PLANNING & ZONING BOARD - CITY OF WILDWOOD
Special Magistrate – Lindsay C.T. Holt

Agenda
Regular Meeting
July 1, 2025 2:15 PM
City Hall Commission Chamber
100 N Main Street

1. **SP 2410-003 Oxford Crossings Racetrac**

DRAWN-BY	JTHOMAS
DATE	9/30/2024
SCALE	1"=30'
DRAWING NAME:	07 GRADE.dwg
SHEET NO.	07
VERSION	2025/05/23 3:22 PM

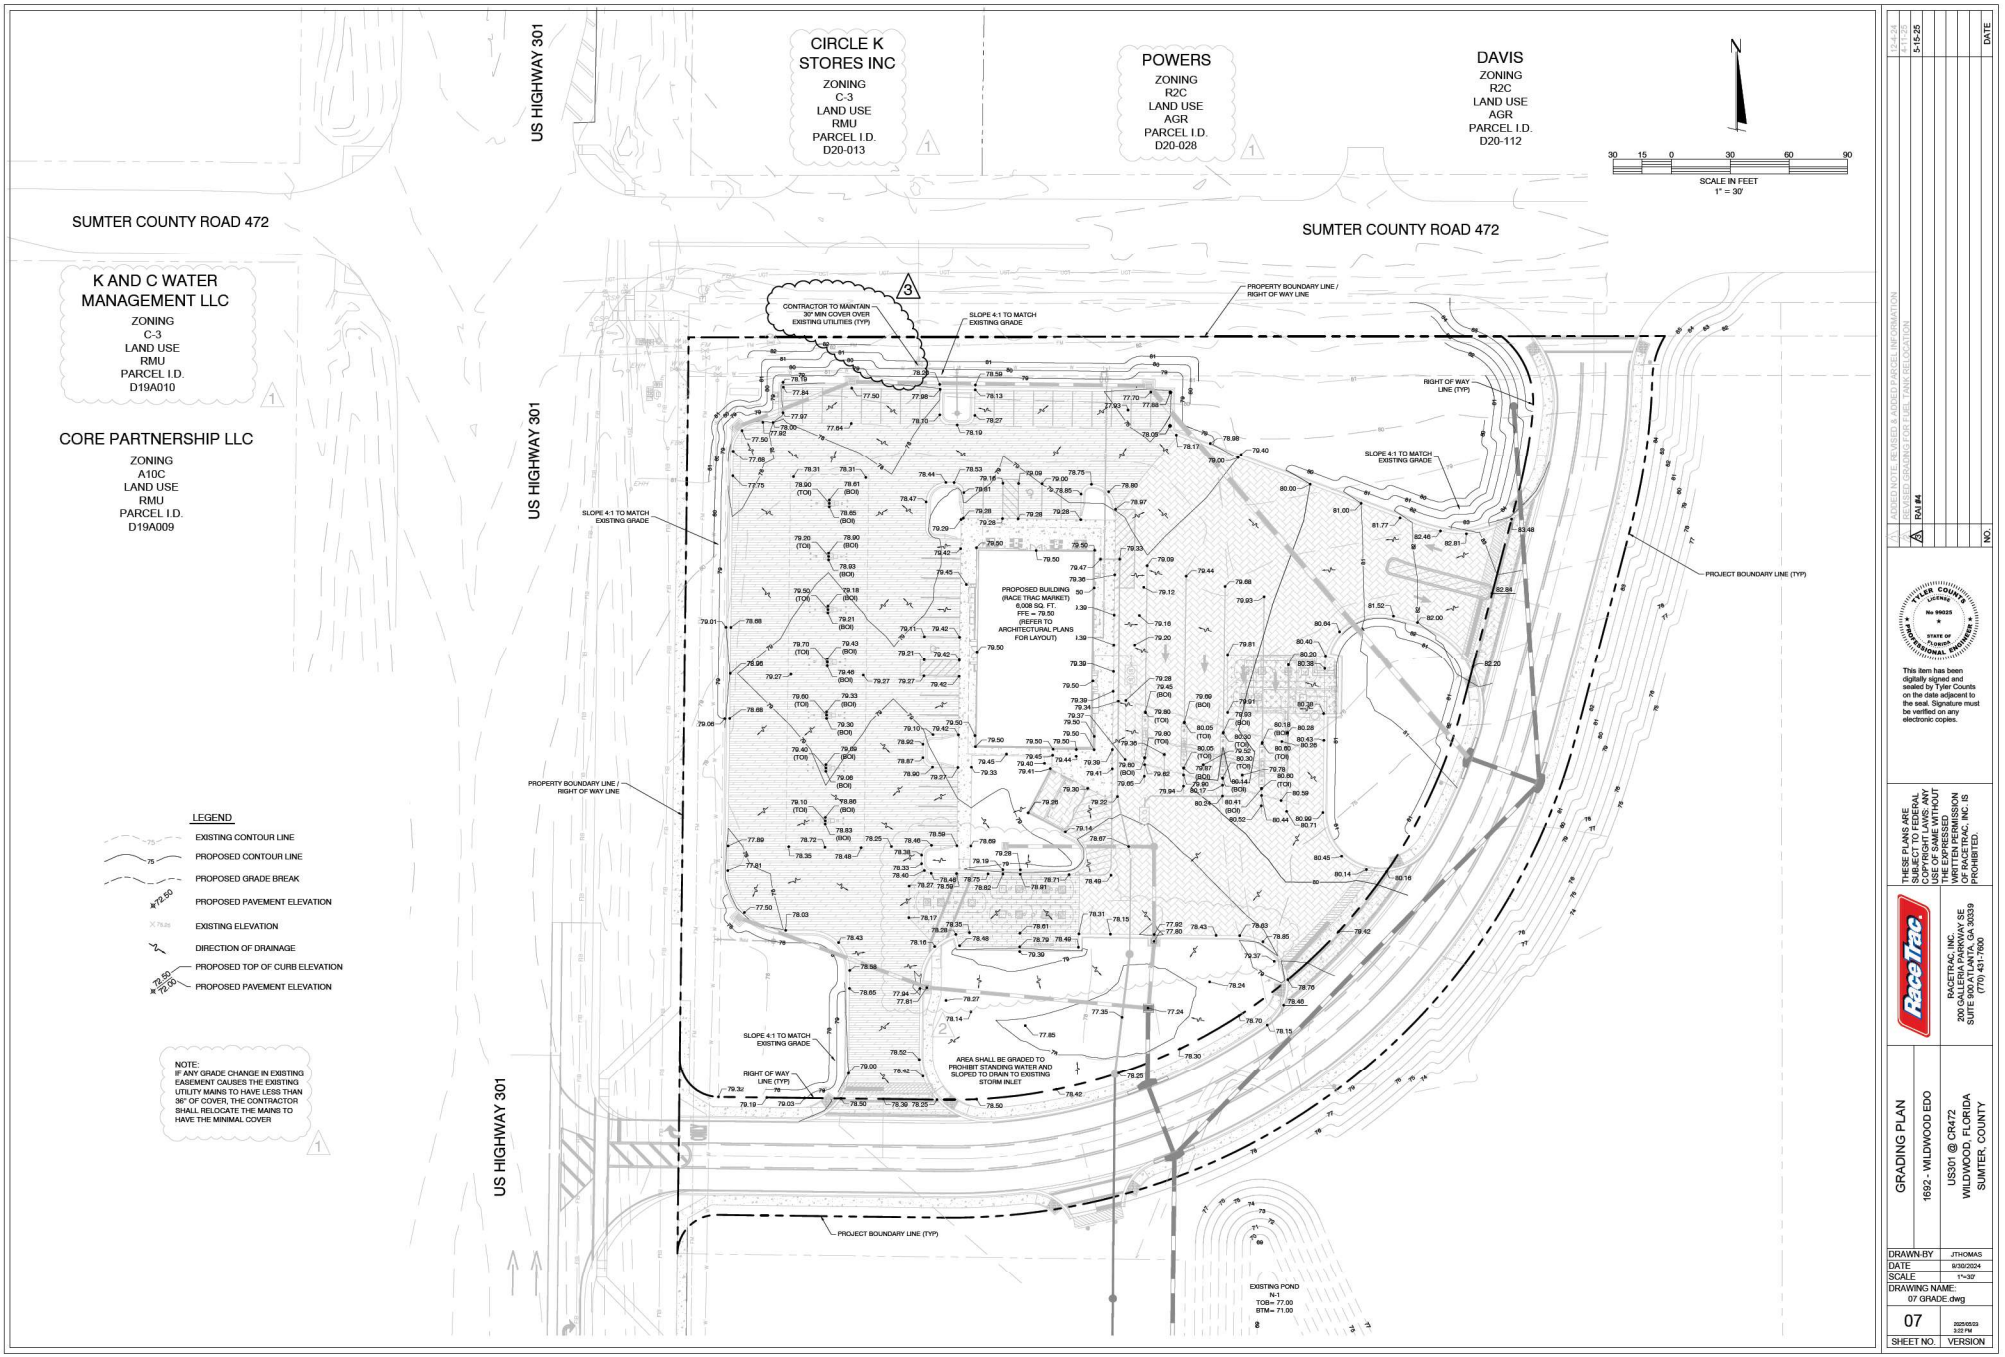
2. LDR 4.4(C)(9) – Please provide a copy of the utility easement referenced on the boundary survey (ORB 1568, P 21). Also please clearly mark this easement on Sheet 07 so that it is visible in relation to the proposed utilities. Additionally, if it is assumed that the end of city maintenance for the fire main is in the existing right of way, please mark the existing right of way for reference.
    - A. Response: Please see sheet 08 of the updated construction plans (sheet 07 on the previous plans is now sheet 08).
        - **I. Comment remains.**
